Our Ref: 2922

Your Ref: MP05\_0062 MOD 2

**RE: MODIFICATION REQUEST FOR ROYAL NEWCASTLE HOSPITAL SITE**

**Drawing**  
 ARVIA VIEW SHARING  
 ANALYSIS\_UPPER FLOORS  
**Scale**  
 1 : 4000 @ A3  
**Date Printed**  
 31/10/2012 9:49:05 AM  
**Project Number**  
 202485  
**Drawing Number**  
 PD14  
**Issue**  
 D

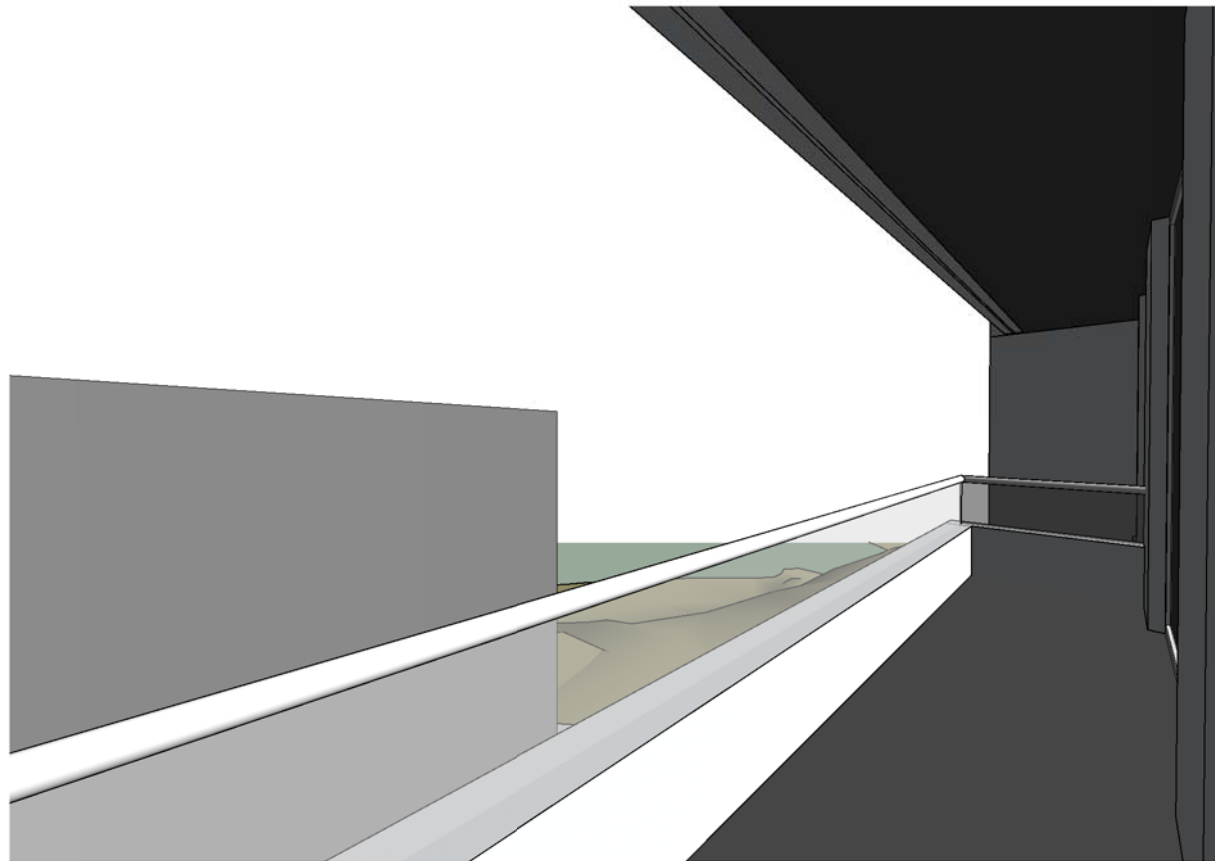
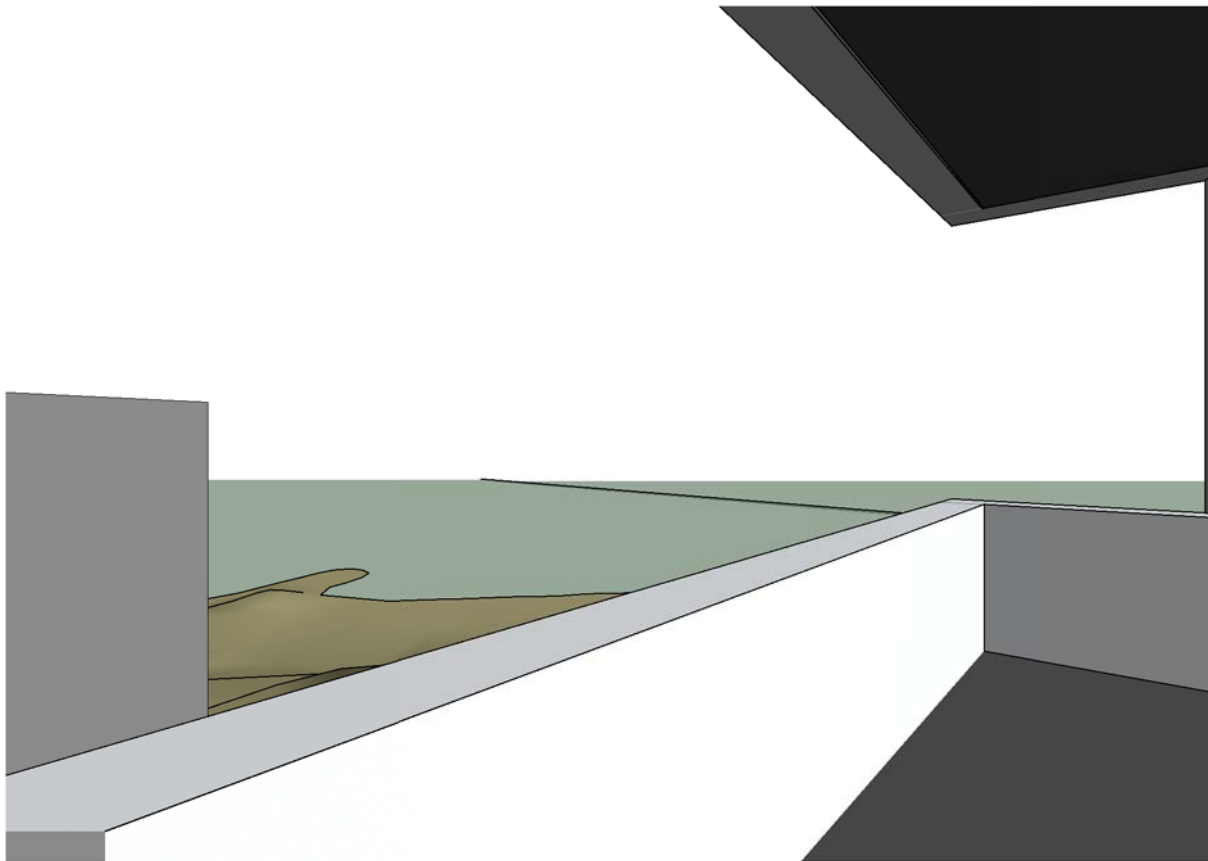
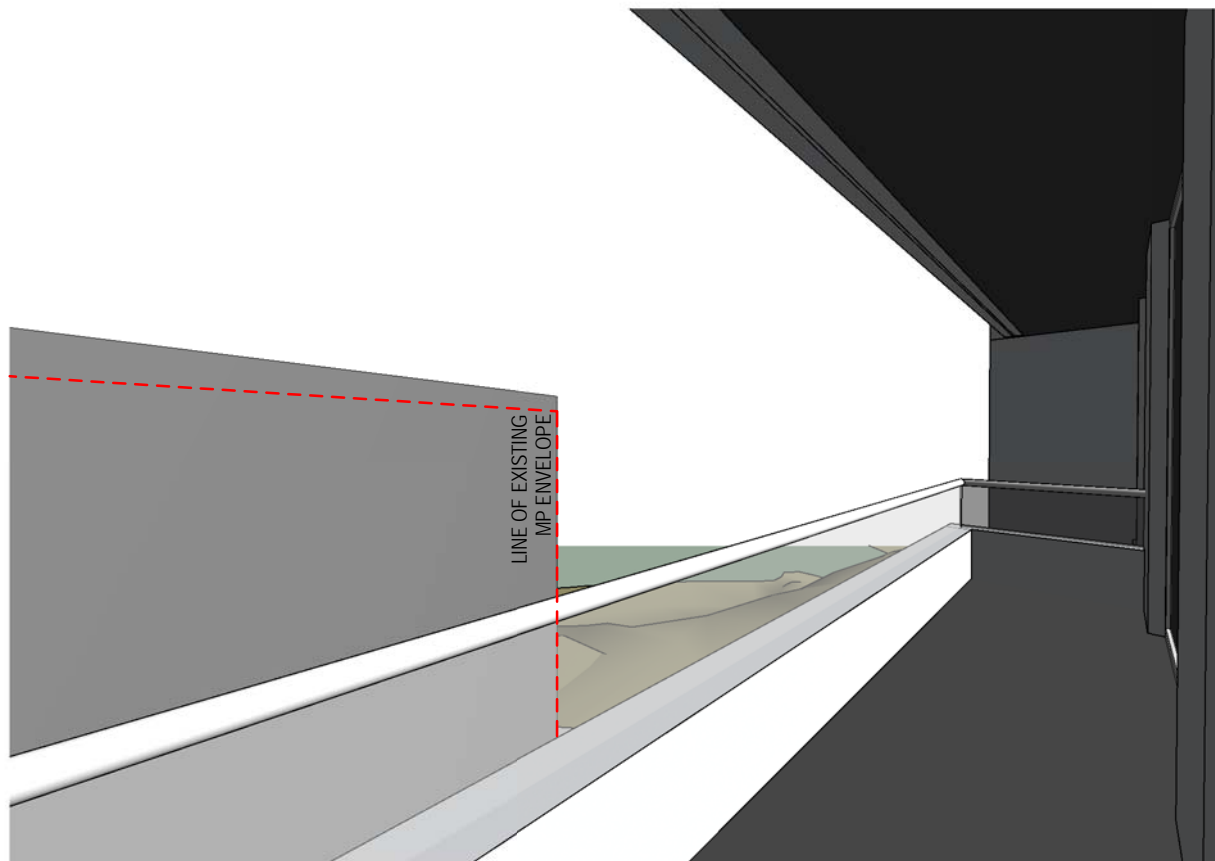
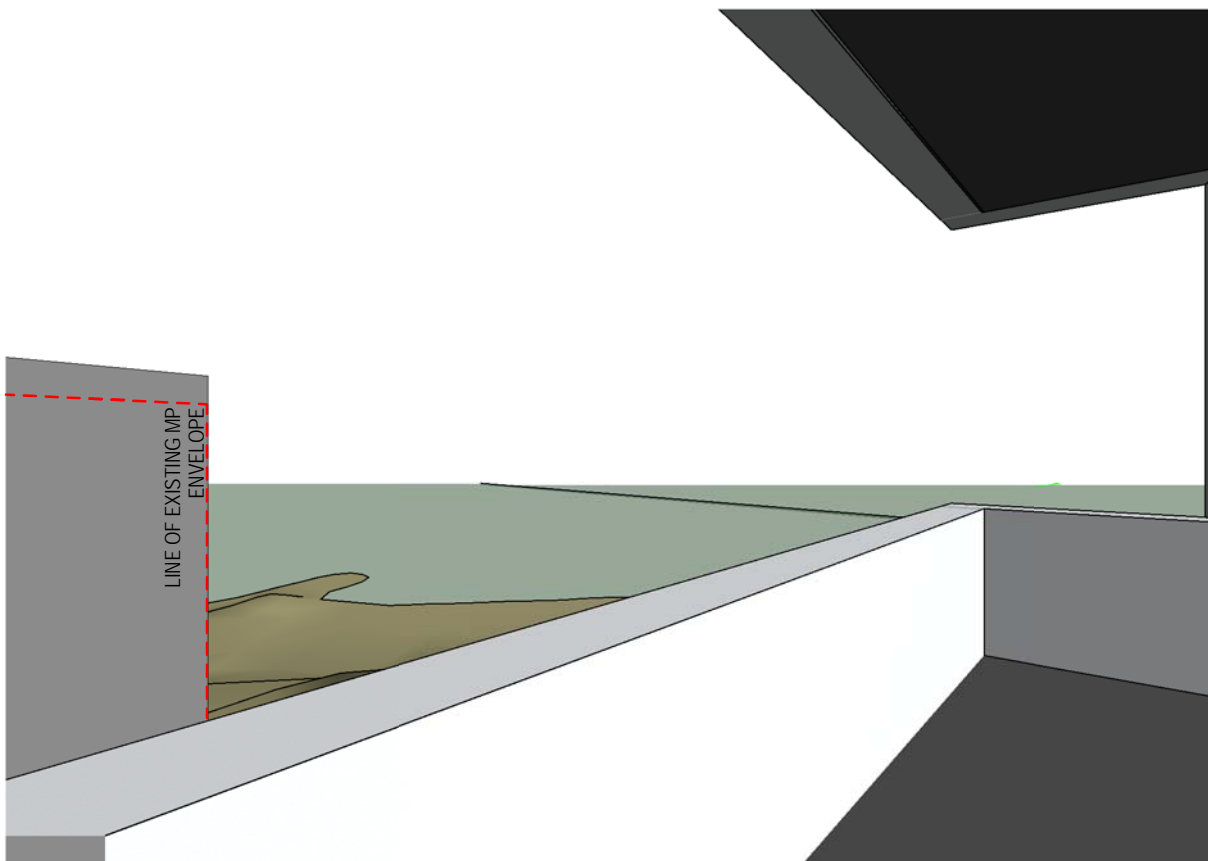
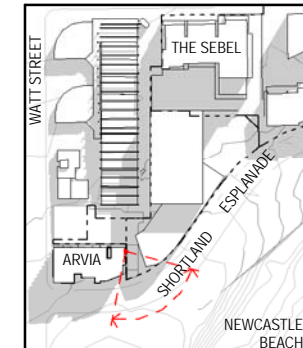
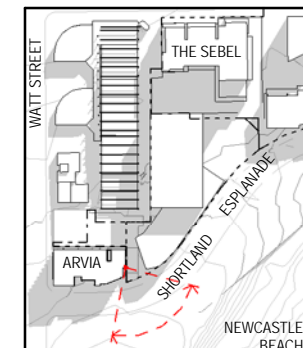
In relation to views from east facing units of the Arvia building which is located immediately west of the site, drawings PD 13 Issue B and PD 14 Issue B, prepared by Suturs Architects and submitted to the Department in a letter dated 14 August 2012, showed the line of the existing concept plan envelope and the extent to which adjusting the envelope in the south east corner of the southern building impacts on views from units in the Arvia building at both upper and lower levels.

Taking into consideration the view sharing principles in *Tenacity Consulting vs Warringah* (2004) NSWLEC 140, it is proposed to splay the building envelope as per the revised building envelope drawing at **Attachment 1**. The impact of splaying the building envelope on views from the upper and lower levels of the Arvia building is demonstrated in the revised drawings PD 13 Issue D and PD 14 Issue D, prepared by Suturs Architects (**Attachment 2**). With respect to consistency between drawing Nos PD13 Issue D and PD14 issue D and previous revisions, the view of Arvia Lower Levels South Living- Existing MP and the marked line of existing MP envelope on Arvia Lower Levels South Living- Proposed MP, the architects have advised that the most recent revision is taken slightly back from the original submission, however the comparisons of existing and proposed in each issue are accurate. It is estimated that the "new point" has been moved by approximately 200mm. The keys in the updated drawings now reflect the altered view angle, notwithstanding that the change is indistinguishable to the naked eye.

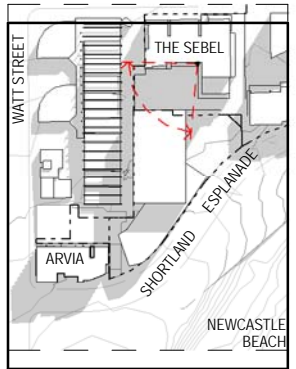
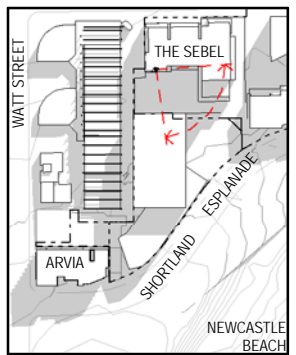
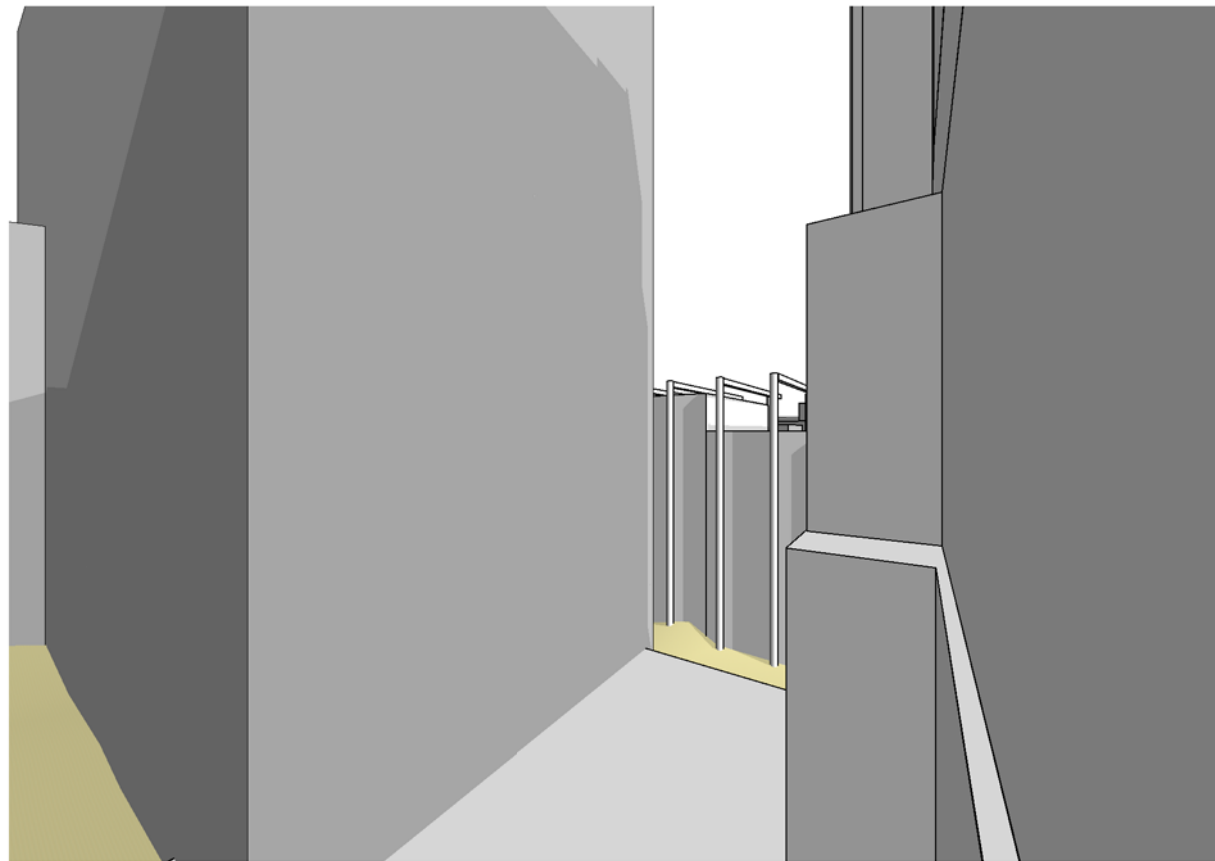
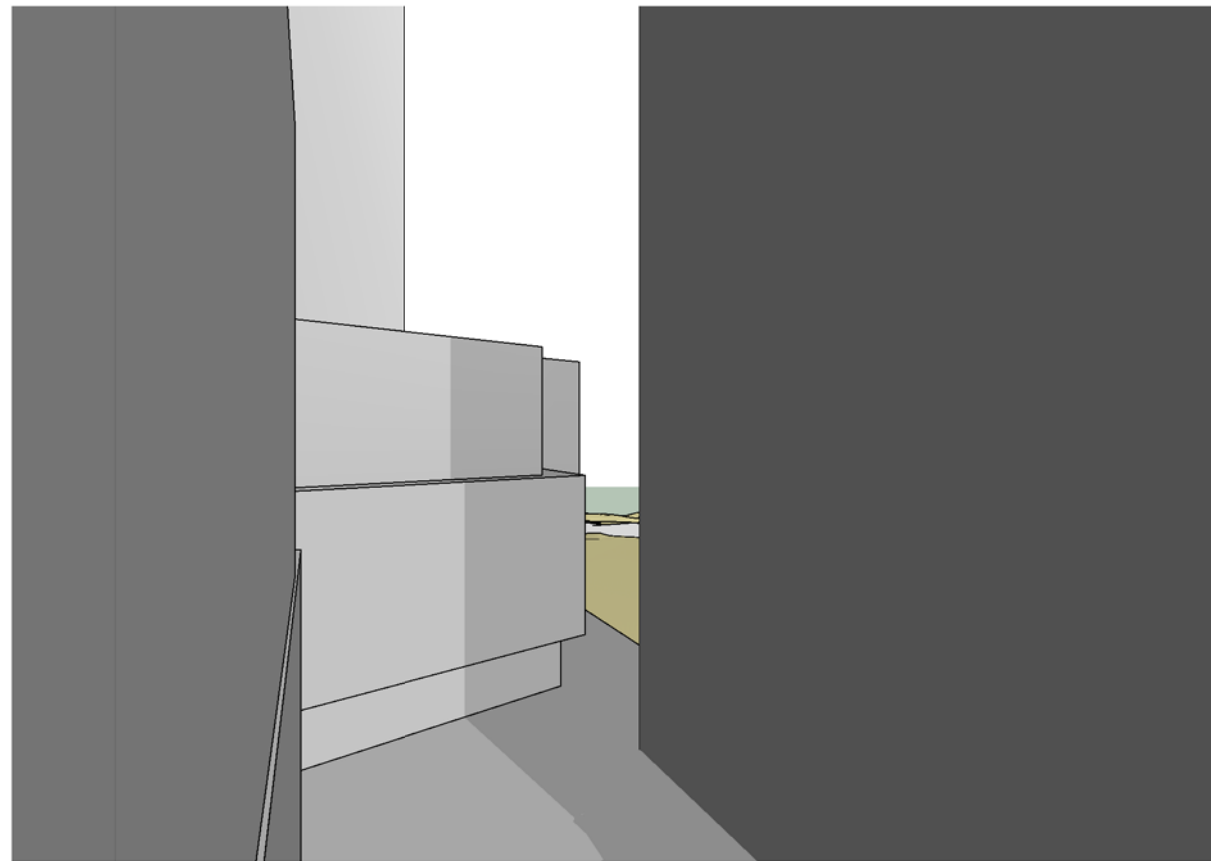
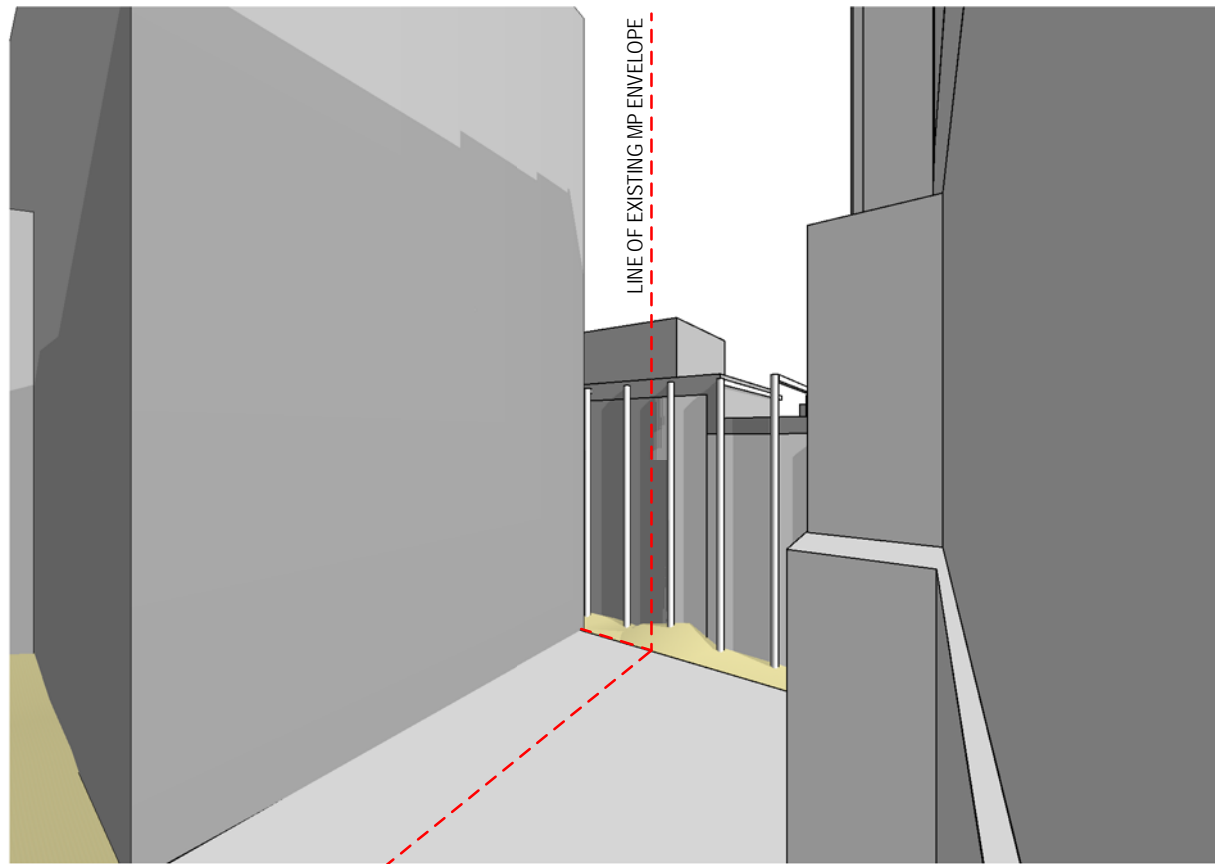
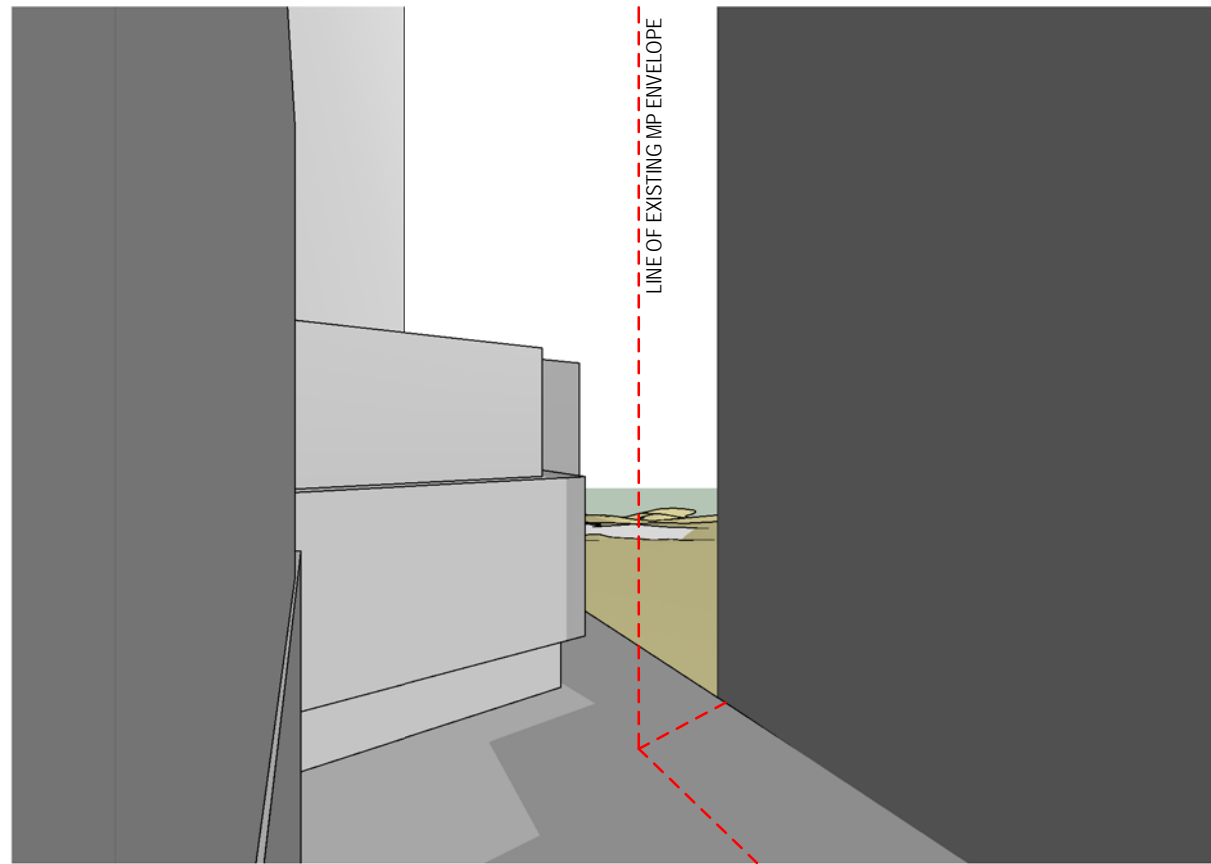
In relation to the completed Mirvac Residential towers to the north, drawings PD 15 Issue C and PD 16 Issue C prepared by Suturs Architects show existing and proposed perspectives taken from two locations within the development (lower and upper) looking west and east. Moving the envelope for the northern building 6.7m further south as proposed, increases the separation between buildings, enhances east and west views and is considered to accord with the view sharing principles set out in *Tenacity Consulting vs Warringah*.
